Access Compliance Report Public Rights-of-Way (Curb Ramps)

Main Street: N/A Cross Street: OSO_PKWY Location: S

ADA ID: RPAT220208133230 Ramp Type: Type 7 - Directional 2 Initial Pass/Fail: Fail Overall Compliance: No Severity Score: 15

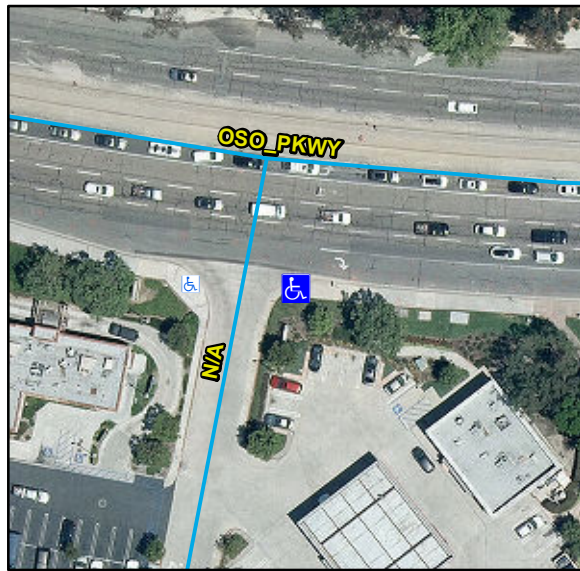
Surveyor Notes:

N/A

Possible Solutions:

Remove & Replace Entire Ramp.
